Access Compliance Report Public Rights-of-Way (Curb Ramps)

Main Street: MELVIN_WY Cross Street: RED_HILL_AVE Location: E

ADA ID: RPRK211014142637 Ramp Type: Type 1 - Perpendicular Initial Pass/Fail: Fail Overall Compliance: No Severity Score: 16

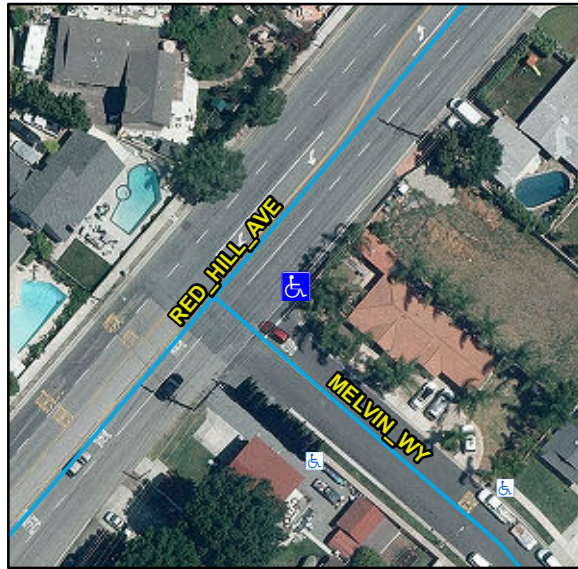
R204.3, R304.5.3, R302.7, STD 1115

Remove & Replace Entire Ramp.
